Groundwater Application Review Summary Form

Application # G- 18734

GW Reviewer Joc Kemper Date Review Completed: 6/7/2019

PUBLIC INTEREST REVIEW FOR GROUNDWATER APPLICATIONS

Figure 2. Well Location Map

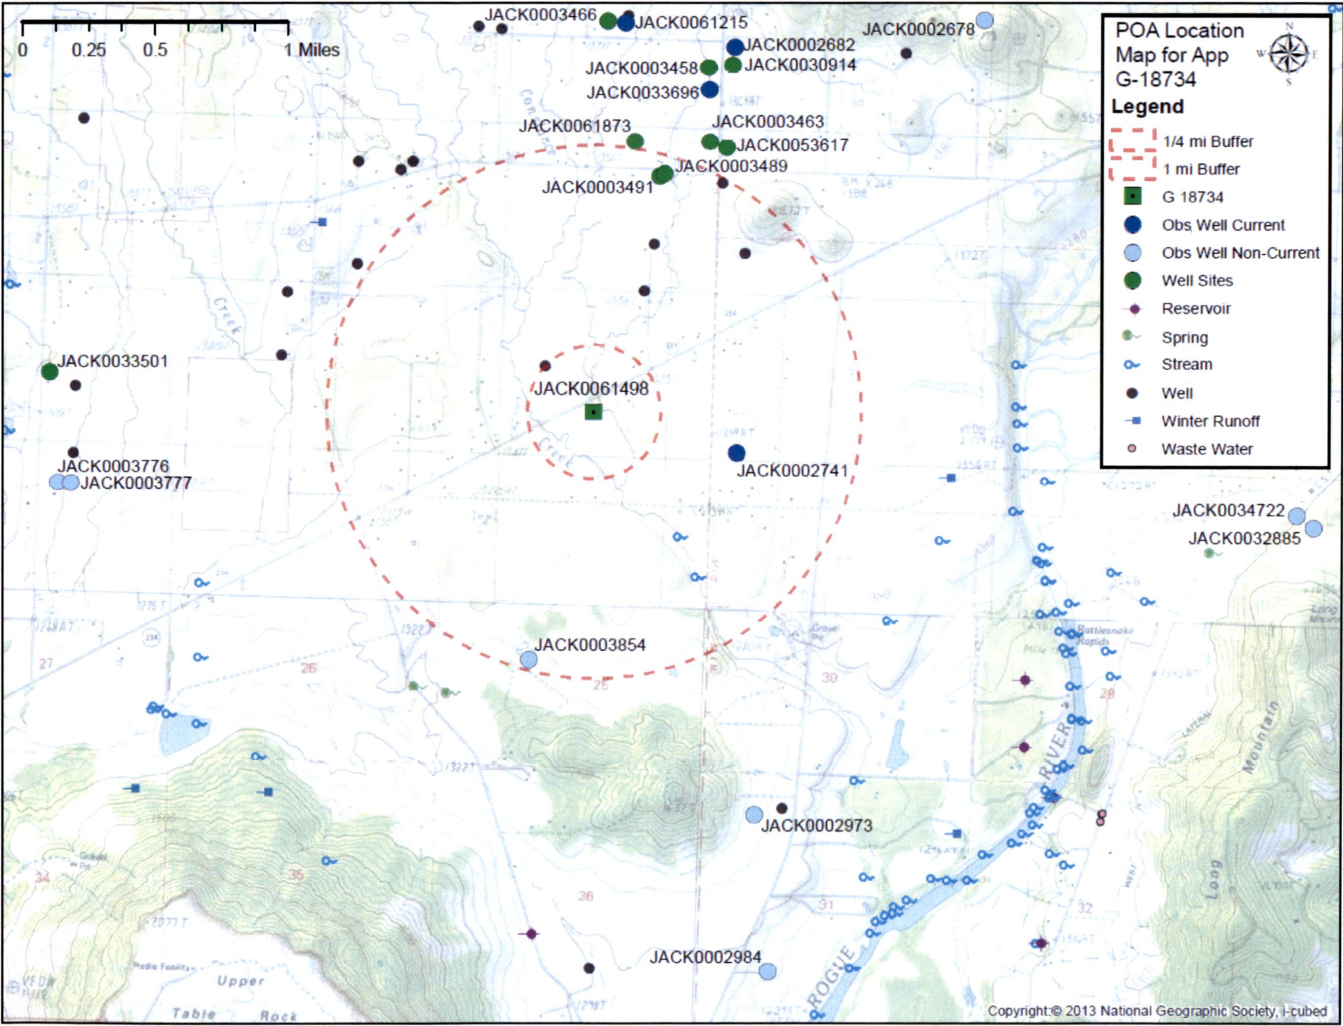
Basis for aquifer hydraulic connection evaluation: Groundwater level measurements in the area are typically shallow (10-30 feet BLS). The applicant's well log indicates a SWL of 45 feet BLS, but SWL measurements that are taken shortly after the drilling/testing process in low yield wells are often deeper than the true piezometric surface of an aquifer system because the water level in the well is still recovering. Groundwater in this fractured bedrock system flows towards and discharges to surface water where elevations are coincident, but there are few water level data in the area to indicate where this specifically occurs. Several lines of evidence indicate that groundwater levels are very shallow near the applicant's well (reported SWLs in adjacent well logs are within 10-40 feet of land surface, the well is located in a riparian lowland, & there is more vegetation in this lowland). Although the applicant's well is located within ¼ mile of Constance Creek, there is insufficient evidence to indicate that the applicant's well is hydraulically connected within ¼ mile to Constance Creek.

C6. **SW / GW Remarks and Conditions:** The applicant's well would access an aquifer that has been determined to be hydraulically connected to Constance Creek. However, there is not a preponderance of evidence that the proposed use/rate has the Potential for Substantial Interference (PSI) as per OAR 690-009.

As noted in section C2, the applicant's well is hydraulically connected to Constance Creek, but there is insufficient data to conclusively determine at what distance (i.e. whether it is hydraulically connected within or outside of ¼ mile). If issued, this permit should have the following conditions to allow for the collection of groundwater level data in anticipation of further development in the lower reaches of Constance Creek:

"The permittee's well(s) shall be equipped with an unobstructed access port at the well head that is at least 1 in diameter and allows direct access to the water column. Upon reasonable notice, the landowner and permittee shall provide the Department access to the well to periodically take manual water level measurements and to install and maintain automatic water-level recording instrumentation."

Figure 3. Water-Level Trends in Nearby Wells

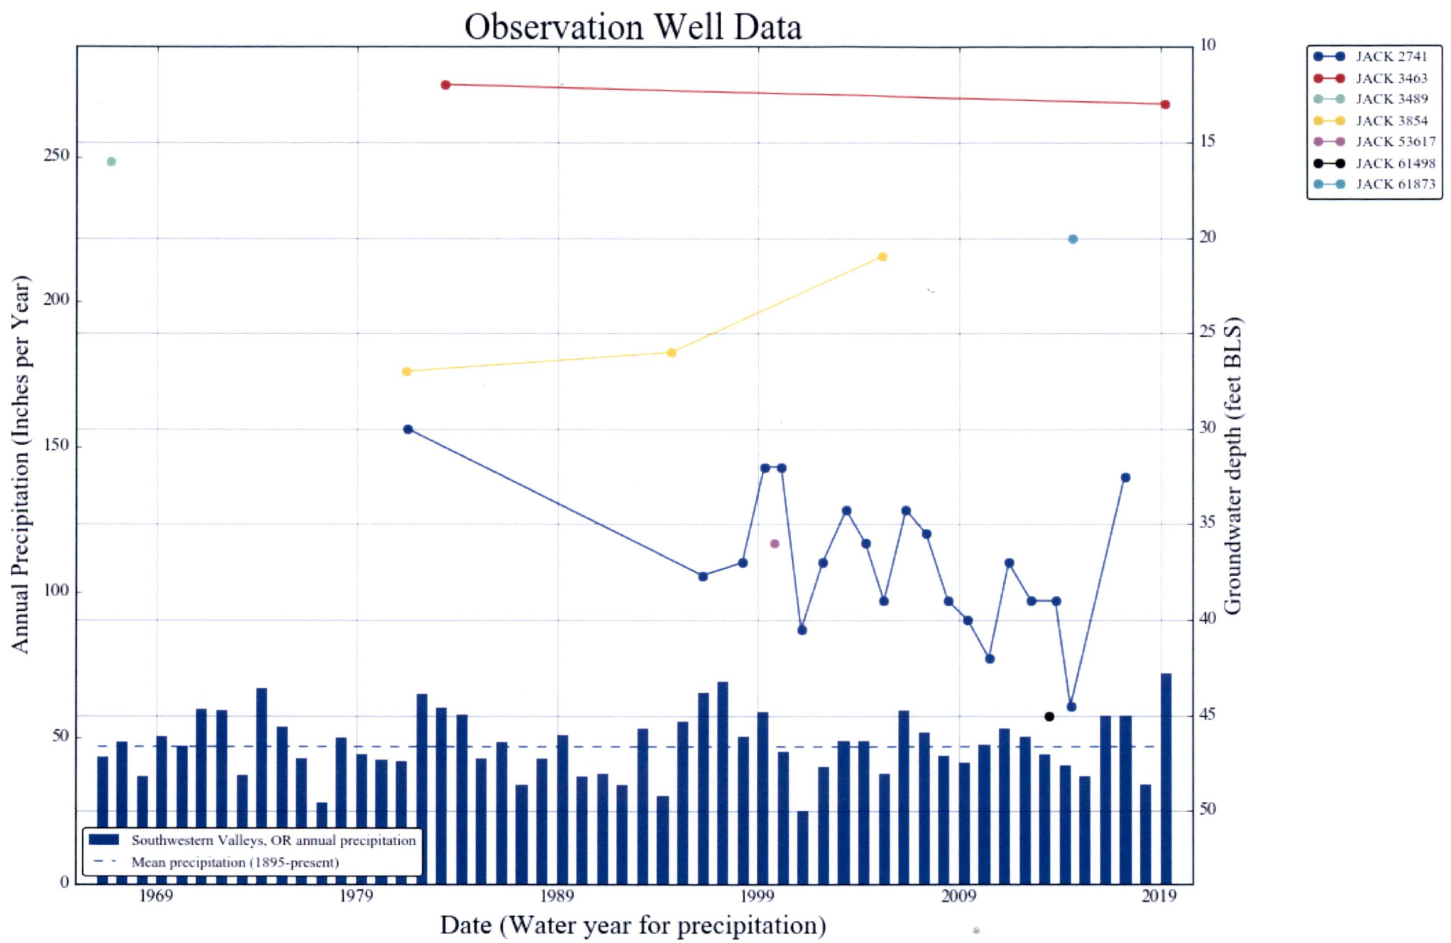
There are limited water level data from wells adjacent to the applicant's proposed POA so Capacity of the Resource cannot be determined and water-level reporting conditions in B1(d) are recommended. There are several groundwater rights within 1 mile of the applicant's proposed POA, so standard interference conditions should be applied. Given the low requested rate however, it is unlikely that the applicant's use would result in injury to other permitted water rights.

- i. ☒ The permit should contain condition #(s) 7C (7-yr SWL); 7J (Scenic); Medium Water-use Reporting ;
 - ii. ☐ The permit should be conditioned as indicated in item 2 below.
